## GROUNDING and SCREENING PHILOSOPHY

This note arises from my action from Monday's meeting to write out the SPIRE grounding requirements explicitly, particularly as regards the bolometer systems. Requirements on the electronics are in **red text**. To present a perspective that is hopefully coherent, the rationale will be included. I appreciate that this will be a restatement of what is already clear to many recipients or regarded as good practise.

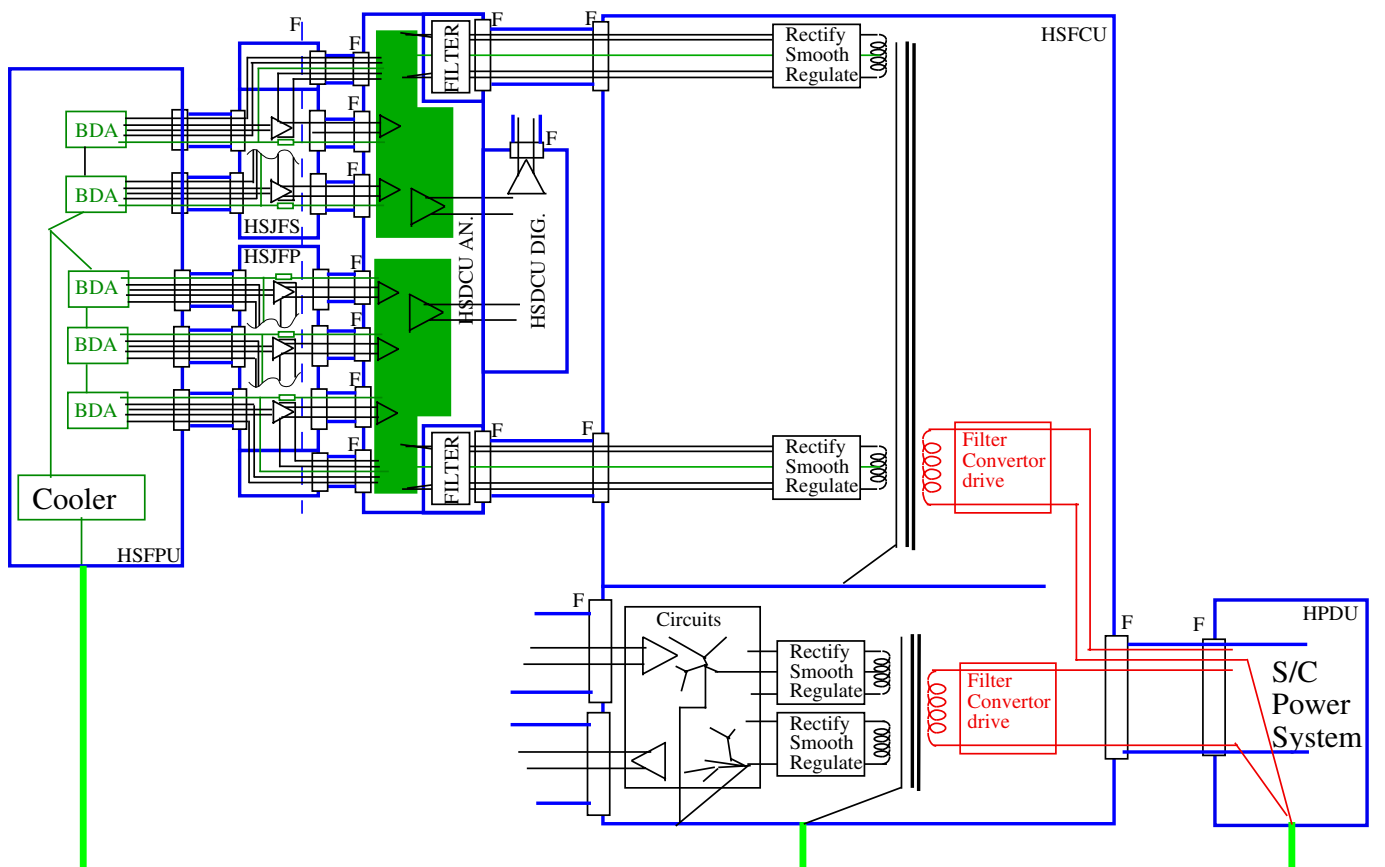
We conceived of the following concept early in the autumn of 2000, following the design decision to separate the spectrometer and photometer JFET units so they could be accommodated adequately near to their respective detectors, the specification then being  $<8pF$  along the cable as seen by each  $5M\Omega$  detector. It was also really stressed by those with experience that Spire's bolometric detectors are unbelievably sensitive and would make corrupted measurements if unwanted r.f. were to be dissipated in them, the biggest risk being that wires have to be attached to them!!

I've used up-to-date acronyms and ignored any redundancy in this drawing to minimise confusion. The essential specifications are:

- signal power gain from external JFET amplifiers
- separate analogue ground paths, without loops, between spectrometer and photometer systems
- maintenance of single point ground joins to S/C chassis

- analogue power, quiet and regulated, supplied from a unit external to the one that houses the sensitive analogue systems.
- ground-plane option invoked to keep a large area of analogue signal ground quiet in each of the spectrometer and photometer parts

- the detectors to be in a Faraday cage with full filtering on all wires entering it (non-bolometer ones not shown) extended with full shielding into the JFET boxes.

- MDM connectors on the JFET boxes not available cryogenic filtered, so a separate compartment division is introduced in the JFET boxes with ceramic feedthrough filtering to close the Faraday cage.

- unipoint analogue ground for the system at the 300mK BDA units that are unavoidable coupled with cold-plumbing busbar ink. This minimises Voltages between the bolometers and their local chassis.

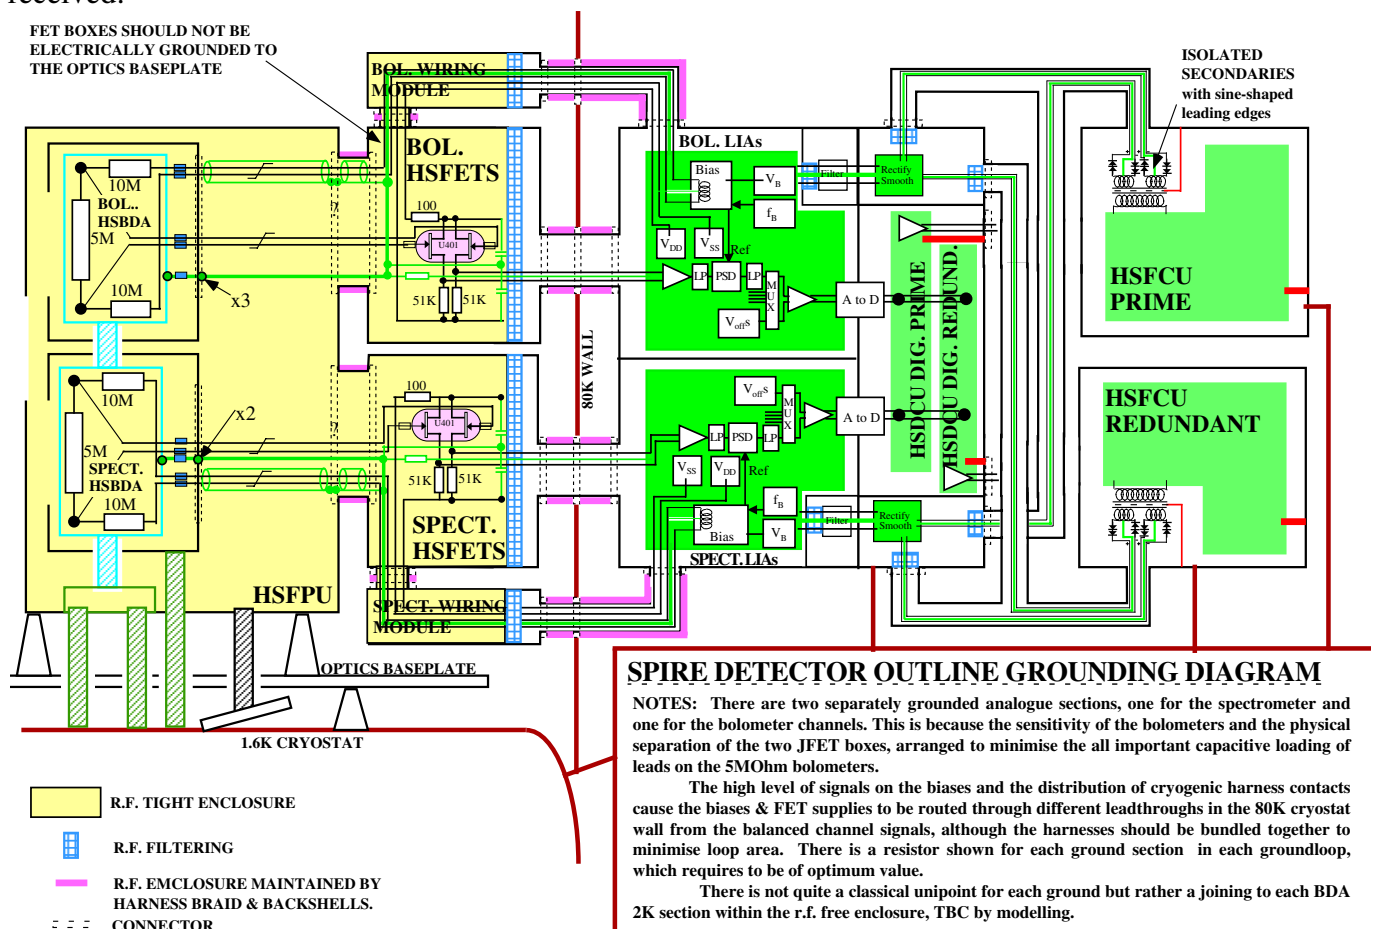
With all the above in mind, and having seen some circuits for the DCU, the following grounding scheme was published in November 2000, was circulated to project, and on which few comments have been received:

I have to be honest and say that this is the version that I now have on my computer and not the exact one from last November, but they differ only in detail.

Before we discuss the middle of this system, let's consider its ends, first towards HERSCHEL. Spire is defined at IIDB level as having a prime DPU and DRCU, plus a redundant pair, non-cross-strapped, of which the Herschel platform shall only empower one half at any one time. Now the DRCU is no longer a physical unit but has been split into two, the DCU and the FCU, both parts shall appear to the DPU and hence HERSCHEL to be simple prime/redundant units. The bolometers and the analogue section of the DCU are non-redundant, the former because it's not clear how they could be built into Spire, and the latter because it's difficult to achieve low noise from a bolometer into two preamplifiers plus the shear amount of electronics involved.

In setting up the grounding diagram with the JFET filters closing the wiring Faraday cage, their chassis have to be electrically isolated from the HERSCHEL optical bench, as noted in the grounding scheme. Please check that the mechanical outline of this is in the thermal model.

It also follows that the tightly bundled cables from the JFET filters to the outside of the FPU have to have a high coverage screen around each of them to keep the Faraday cage closed. However it's vital that these cables be heatsunk to the optical bench to minimise JFET heating of the FPU, so they need an external insulator at least where they are clamped. I believe that the thermal budget can stand an external shield around these cables [besides the 12-ax braids that I would like to keep insulated and associated with signal ground not chassis] terminated one end on JFET connector backshells and the other to the FPU wall. Please check that the mechanical outline of this is in the thermal model.

On the requirement of having an insulator on the shields of the BDA harnesses, I don't think an insulator is needed from JFETs to BDA as the shield will only short to the FPU. Correct?

Finally, making a ground connection at 300 mK may present some problems. It may have to be a wire bond connection, and that makes me nervous. There is very, very little room in the BDA. I don't know if we can clamp the kapton cable and make a reliable contact. So we will make it possible to connect at 2 K.

YES BUT MAINLY NO. INSIDE FPU IS DEBATABLE BUT I DO NOT WANT TO START WITH MULTIPLE UNAVOIDABLE JOINTS BETWEEN FARADAY CAGE AND SIGNAL GROUND. OUTSIDE THE FPU DEFINITELY NO BECAUSE THE HARNESS IS HEATSUNK TO OPTICAL BENCH AS IT LEAVES THE JFETS AND UNINSULATED IT WOULD COMPLETELY SHORT OUT WHAT YOU ARE CORRECTLY SO KEEN TO PRESERVE IN THE "RE-EMPHASIS".

THE GROUNDING DIAGRAM DETAIL PRESENTLY SHOWS JOINS AT BOTH PLACES, BUT SUBJECT TO MODELLING AS STATED. I ALSO WOULD BE NERVOUS ABOUT WIRE BONDS FROM KAPTON CABLE TO CHASSIS, BUT I CANNOT SEE WHY SOME EXPOSED METALISATION AROUND THE HOLES THROUGH WHICH DOWELS/SCREWS PASS TO HOLD DOWN THE END OF THE KAPTON HARNESS, WITH FLARED CROSS-SECTION ON TO TRACKS AND MAYBE WITH SLIGHTLY RAISED CLAMP SURFACE AROUND DOWELS/SCREWS SHOULD NOT PROVIDE A VERY SECURE GROUND. AFTER ALL IT HAS TO HOLD THE KAPTON WELL ENOUGH THAT A LARGE NUMBER OF VERY FINE WIRE BONDS TO THE DETECTORS/RESISTORS REMAINS INTACT DURING VIBRATION AND TEMPERATURE CYCLING.

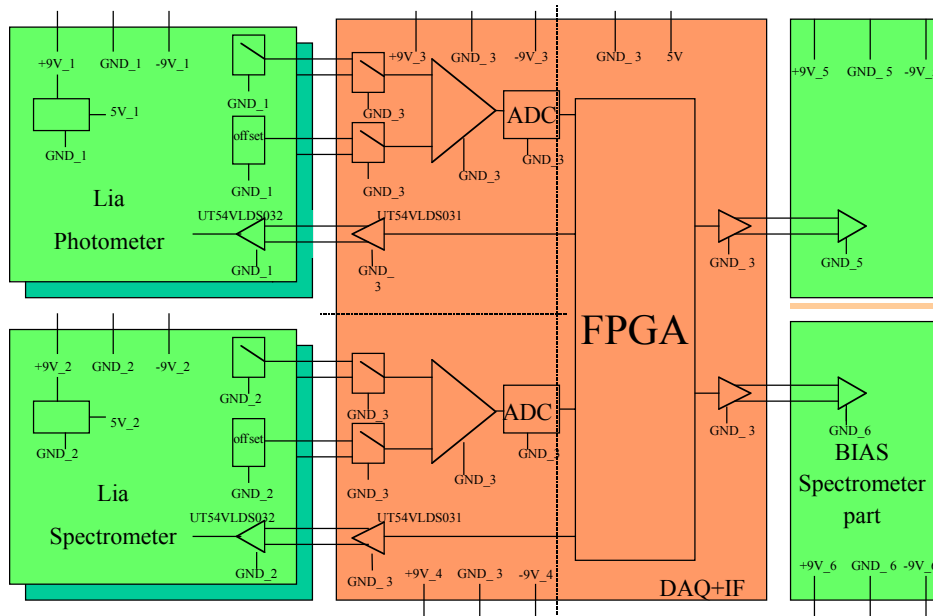
Now consider some more of the FPU grounding details. I have to admit that thinking things through to write this all out has made me aware of some details I'd overlooked. In keeping with the unit to S/C ideas spelt out above, all three main FPU mounting feet need to include electrical breaks, probably as necked

plus simple bushes/washers at one end or the other. This is probably a new electrical requirement to be identified at system level, except that as has been pointed out it is actually part of a long-standing JPL bolometer requirement that the Faraday cage be isolatable. Thermally this should be no problem as the feet are seeking to achieve isolation anyway. Mechanically the feet have to keep instrument alignment with the HERSCHEL telescope, so good tolerancing becomes essential at the isolated end to remove any slop as metal dowels etc. that end used as part of an alignment procedure would short out the insulation.

I originally thought the BDAs might form a Faraday cage themselves with an electrical break in the 300mK plumbing, but the BDA 300mK sections are suspended from 1.8K mounting rims linked by open Kapton ribbon harnesses which precludes this approach by definition...without thermally shorting out the Kevlar suspension. I had not at that stage caught up with the agreement that the FPU was the Faraday cage, and this approach was quickly reverted to. However, back in November, I outlined a marginally non-ideal configuration. The 1.8K BDA mounting rims interface to two almost closed boxes inside the FPU Faraday cage and are also places where internal signal grounds can be joined. The two boxes are themselves joined by a conducting thermal strap internal to the FPU box. I therefore show all of this joined in something akin to an internal distributed analogue ground plane that almost forms an internal secondary shield. In unit electrical grounding terms it is analogue ground isolated from chassis.

Now we come to a trade-off which RAL intends to resolve at system level first by estimation using a computer grounding model and second by test verification. This is, "Where do we join the bolometer analogue ground to chassis?". Viktor has expressed a preference for grounding it all at the DCU and having the cryogenic end including the FPU Faraday cage all isolated. The above grounding scheme actually baselines the opposite approach which is to isolate the DCU end and to electrically ground the very sensitive cryogenic end to cryostat by using the four electrical links that result from the thermal design. I have yet to see results from the computer grounding model and the safe baseline is to use electrical breaks in the four FPU thermal straps shown on the grounding diagram. Bruce is sure that there is an applicable qualified ISO way of doing this mechanically with sapphire sandwiches.
